STATE OF CALIFORNIA  
ENERGY RESOURCES CONSERVATION  
AND DEVELOPMENT COMMISSION

In the Matter of: ) Docket No. 03-AFC-2  
)  
)  
Application for Certification for )  
the Los Esteros Critical Energy )  
Facility Phase2 )

**COMMENTS OF CARE ON THE PRESIDING MEMBER'S PROPOSED  
DECISION FOR THE LOS ESTEROS CRITICAL ENERGY FACILITY**

**FIGURE 1**  
**Annual Percentage PM<sub>2.5</sub> Contributions from Various Source Categories**

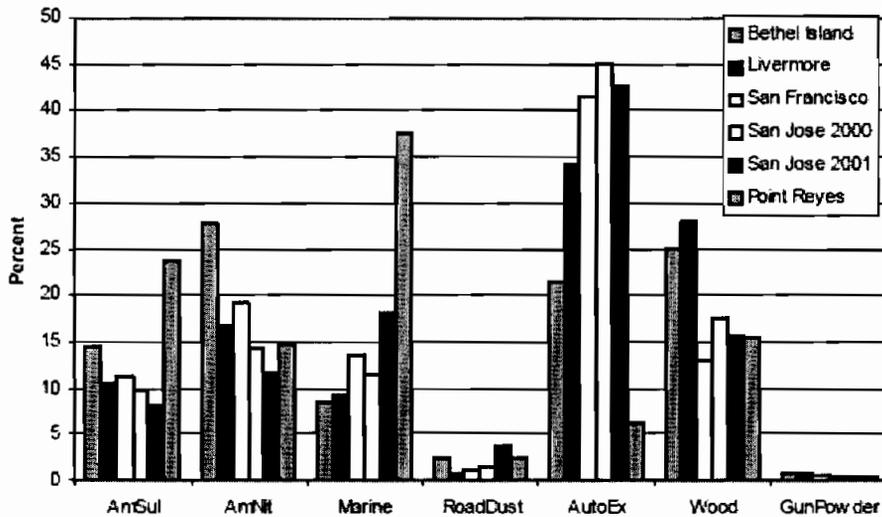
The ammonia emissions from the LECEF are a regional problem because the ammonia emissions will in fact impact other parts of the BAAQMD and even other air districts. The ammonia emissions impacts are not limited to Livermore and San Jose, this is where the reasoning of the PMPD fails, even if it were true that the BAAQMD ten year old study was in the record and could be relied on to support this Decision. As demonstrated below from the BAAQMD September 12, 2005 "Staff Report Proposed Particulate Matter Implementation Schedule" figure1 page 5 [http://www.baaqmd.gov/pln/pm/sb656\\_staff\\_report.pdf](http://www.baaqmd.gov/pln/pm/sb656_staff_report.pdf) contributions to PM are varied throughout the BAAQMD. **A 10 year old limited report that is not in the record** on two locations in the nine county BAAQMD is not sufficient evidence to reach the conclusion that a 10ppm ammonia slip will not contribute to PM levels in the BAAQMD.

Staffs testimony accounts for the fact that ammonia emissions are not emitted in a small box that we can analyze in a vacuum. Staff’s testimony is in fact supported by substantial evidence that is contained in the record on conditions in the project area related to ammonia concentrations.

Ammonia emissions should be limited to 5ppm since the only scientific study in the record (Exhibit 2 p. 4-5) supports staff's testimony that the ammonia emissions have the potential to form secondary PM 2.5 because the project area and the Bay Area are not uniformly ammonia rich. Ammonia emissions which are 75% of the LECEF phase 2 incremental nitrogen deposition impacts should be mitigated because Phase 2 ammonia emissions are not mitigated.
